GWF Henrietta Peaker Power Plant Project (01-AFC-18)

Amendment 2

California Energy Commission

April 2013

FIGURE 2-1a
Water Balance, Peak
GWF Henrietta Peaker Plant

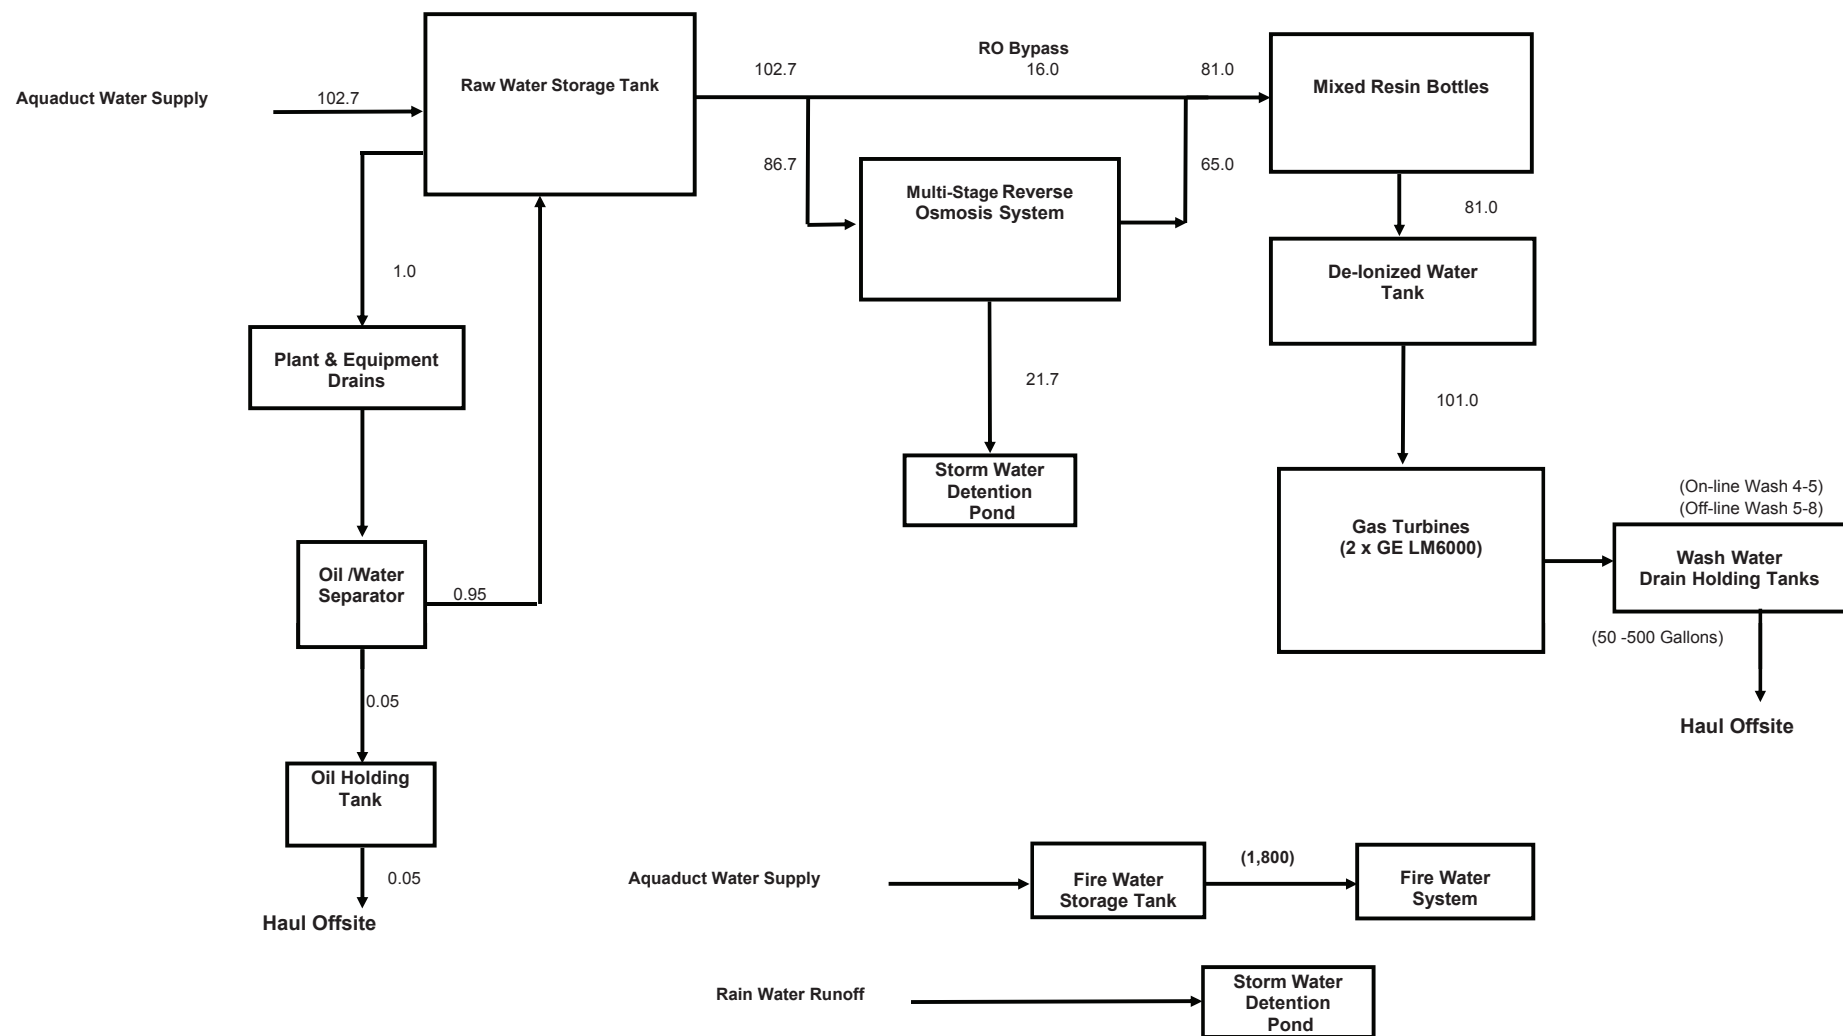
GWF proposes to discharge the RO reject water to the facility’s storm water basin. Figures 2-1a and 2-1b present water balances for peak and annual average water use, respectively. The RO treatment system would require the use of approximately 400 gallons of an anti-scalant for water treatment. This material would be contained in a single tote located near the existing water treatment area. Appendix A is a copy of the Material Safety Data Sheet for the anti-scalant.
